**BEFORE THE INDEPENDENT HEARINGS PANEL
APPOINTED ON BEHALF OF THE WAIMAKARIRI DISTRICT
COUNCIL**

IN THE MATTER OF the Proposed Waimakariri District
Plan - Hearing Stream 12E -
Rangiora, Kaiapoi, Woodend,
Variation 1

AND the submissions of B & A Stokes on
the Proposed Waimakariri District
Plan (#214) and Variation 1 (#29)

**JOINT WITNESS STATEMENT
Stormwater**

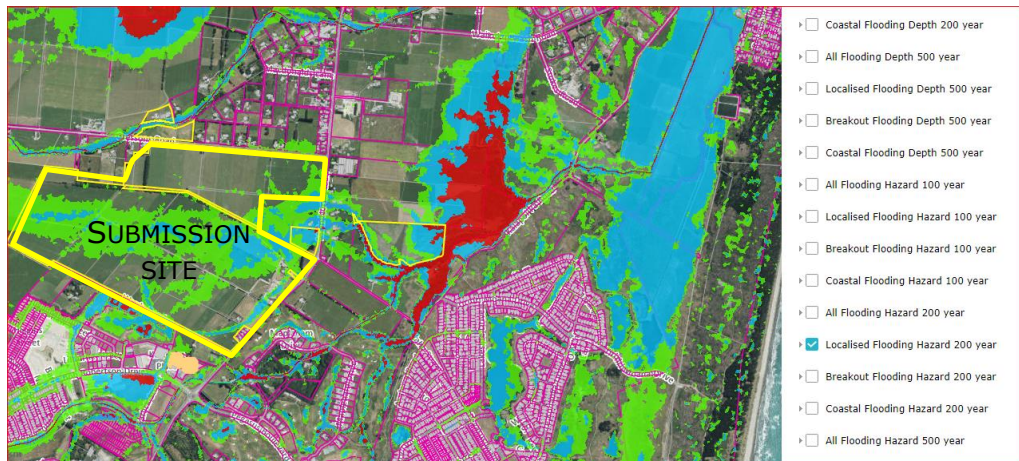
2.3 The Waimakariri District Council’s 1-in-100 year Localised Flood Hazard modelling indicates there is an area of High flood hazard (red shading) that starts around 215m downstream (east) of the site. Refer below;

2.4 The Waimakariri District Council’s 1-in-200 year Localised Flood Hazard modelling indicates there is a similar area of High flood hazard

(red shading) that starts around 215m downstream (east) of the site. Refer below;

2.5 In summary, for the Localised Flood Hazard, there is only a minor difference between the 100yr and 200yr High Hazard areas.

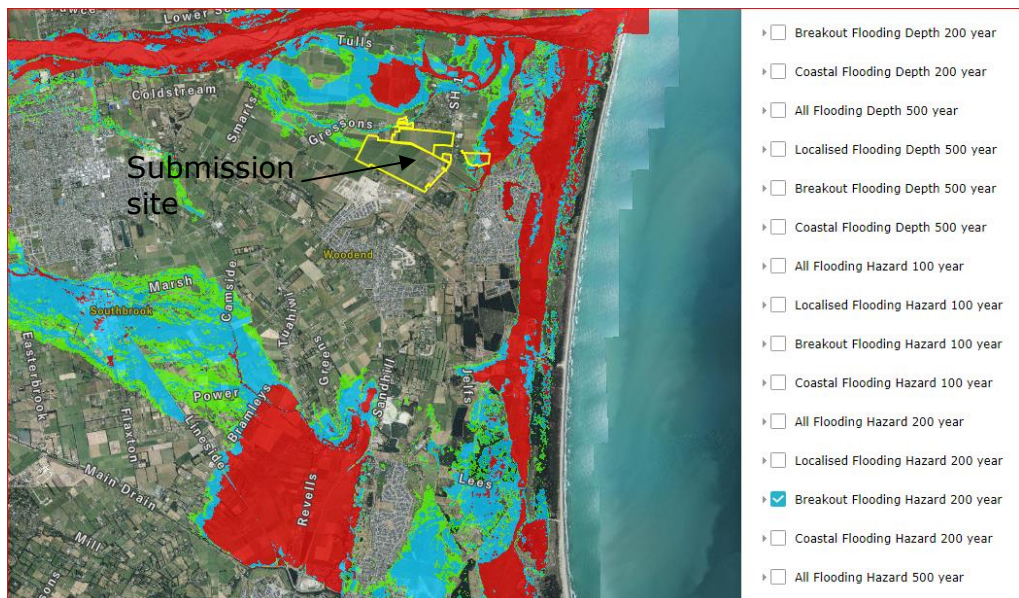
2.6 The Waimakariri District Council's 1-in-200 year Ashley River Breakout Flood Hazard model indicates there is a much larger area of High flood hazard (red shading) that will occur in a Breakout scenario that would affect large areas to the east. Refer below;
